SUPPLEMENT TO THE APPLICATION FOR SITE CERTIFICATE FOR THE KLONDIKE III WIND PROJECT

Klondike III Wind Power Project

Response to First Request for Additional Information (RAI) – Dated July 8, 2005

Response to Second Request for Additional Information (RAI) - September 15, 2005

Figure L-4: Visibility Analysis, Washington

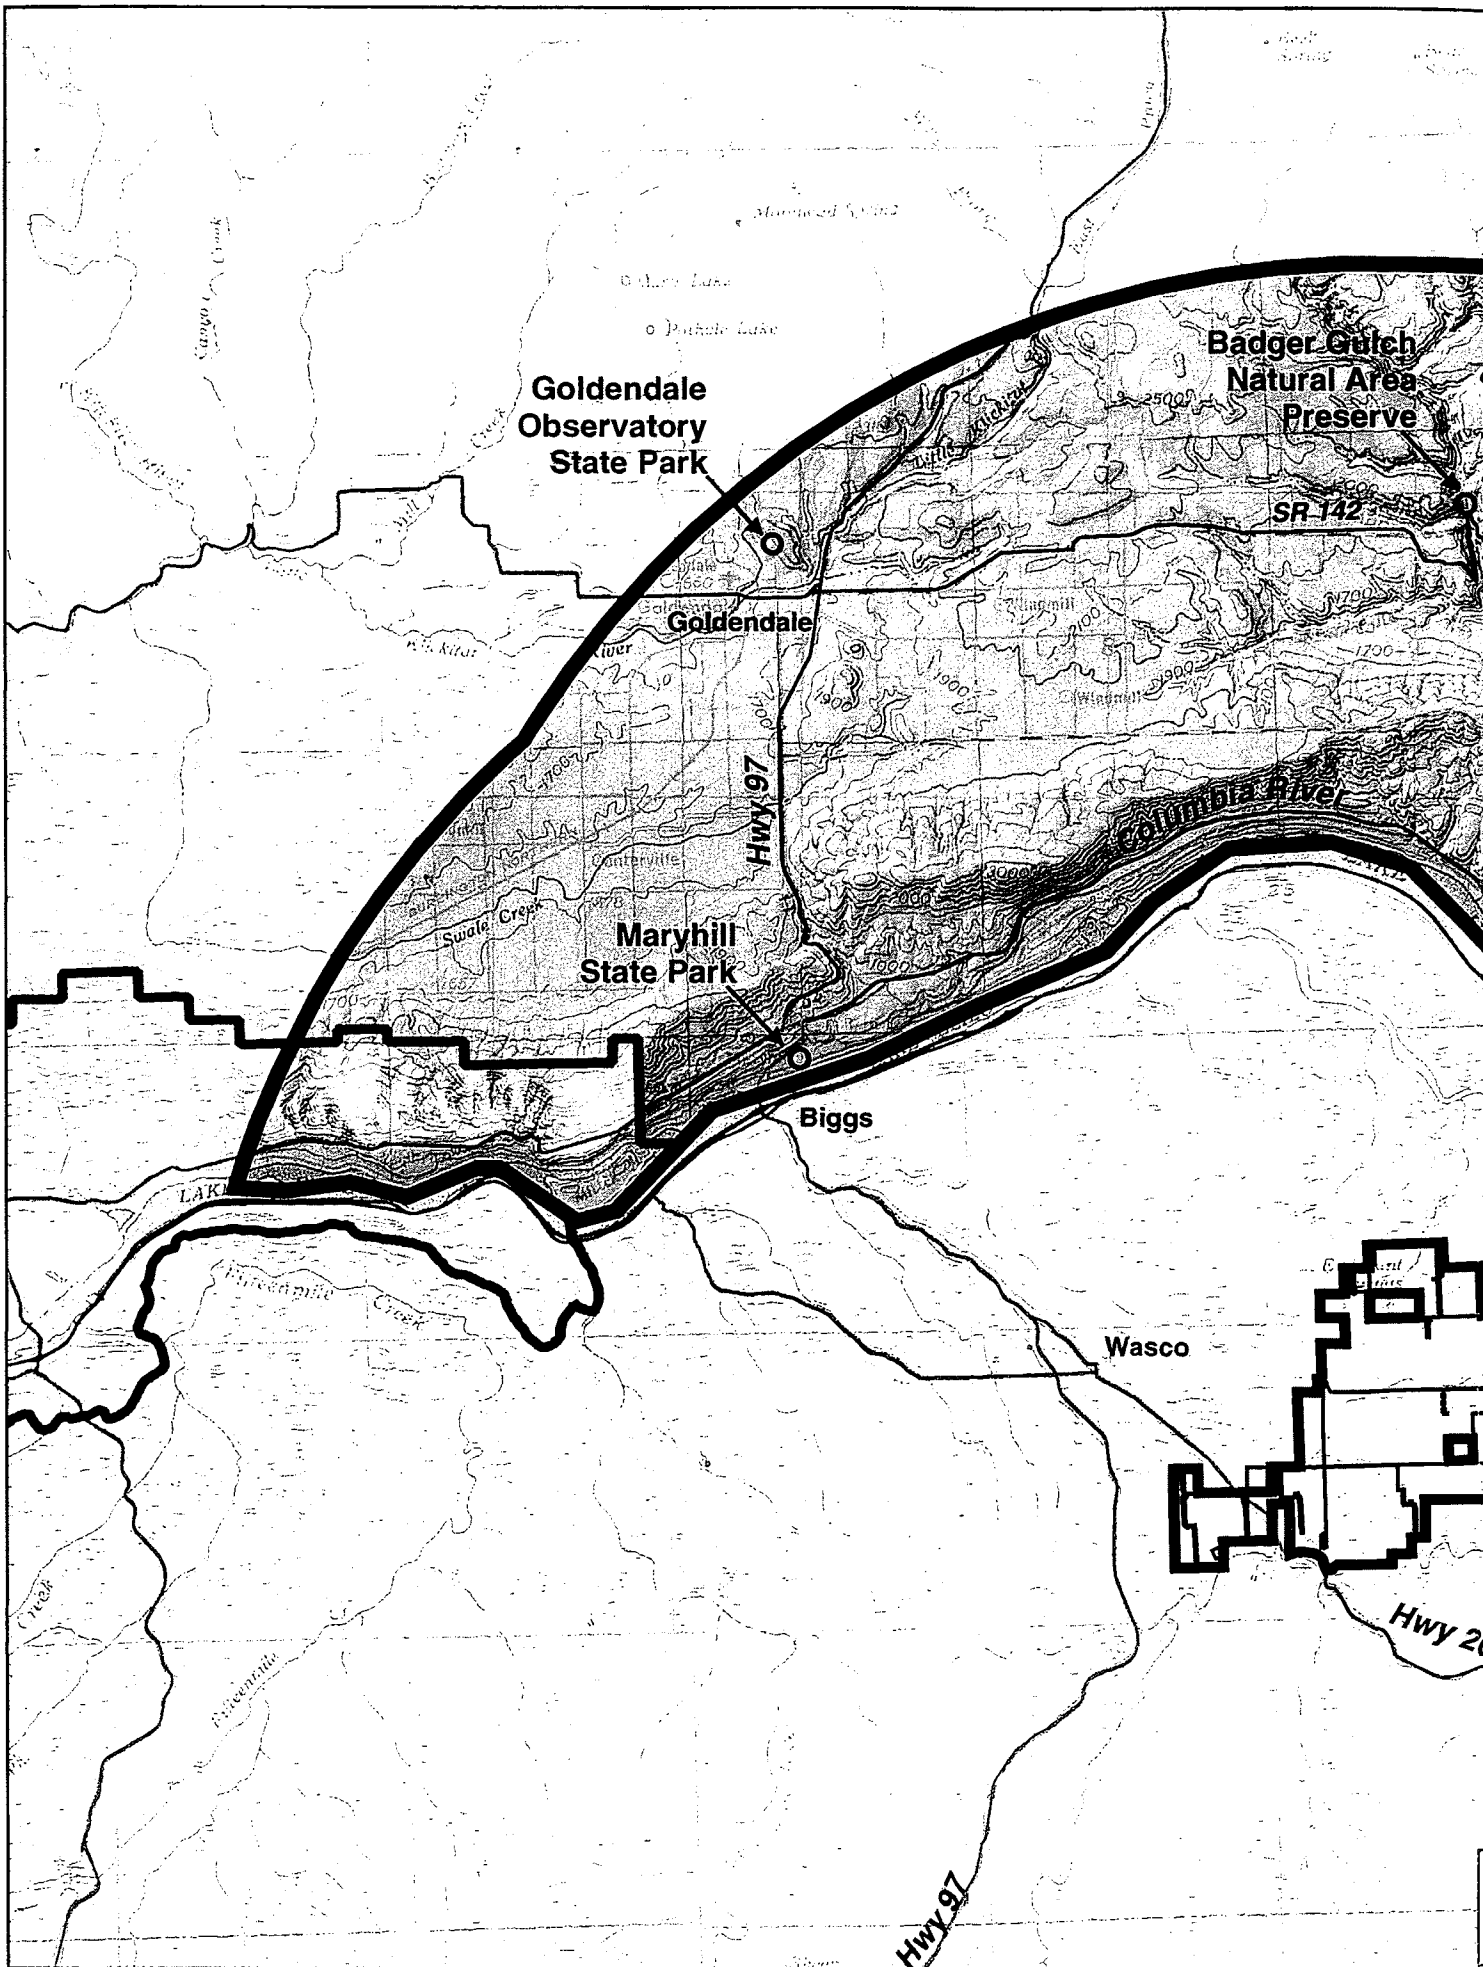
Exhibit L - Protected Areas		
L3	L-1	<p>Provide an analysis of any protected areas in the State of Washington that are within the 20-mile analysis area.</p> <p>Response: An analysis of State of Washington protected areas within the 20-mile analysis area is attached as Revised Exhibit L in Appendix L.</p>
L4	L-2	<p>Provide an analysis of whether noise from construction or operation of the proposed facility would be audible at any of the protected areas within the analysis area.</p> <p>Response: Noise levels from the wind turbine array were modeled at the three closest points on the boundary of the protected area (John Day Wildlife Refuge), approximately 0.8 miles away. No topographic shielding was included, making the model conservative. Sound levels from the turbines when all turbines are operating at the maximum sound power level are estimated to range between 27 and 30 dBA. This results in overall levels of 30 to 31 dBA when added to an assumed background level of 26 dBA. The increase over background levels would be 4 to 5 dBA during quiet background periods. An increase of 4 to 5 dBA is audible. At these low overall sound levels, the turbines might be audible in quiet areas away from flowing water during low wind conditions. However, it is probable that the sound could not be specifically identified to the source without visual cues.</p>

Response: The analysis area for impacts on Protected Areas includes the area within the site boundary and extends 20 miles beyond the site boundary in Oregon. As requested by ODOE, the analysis area has been expanded into Washington. Figures L-1 and L-2 illustrate the analysis area and 12 identified Protected Areas in Oregon and four identified Protected Areas in Washington, respectively. Table L-1 lists these Protected Areas and their approximate minimum distance from the proposed facility.
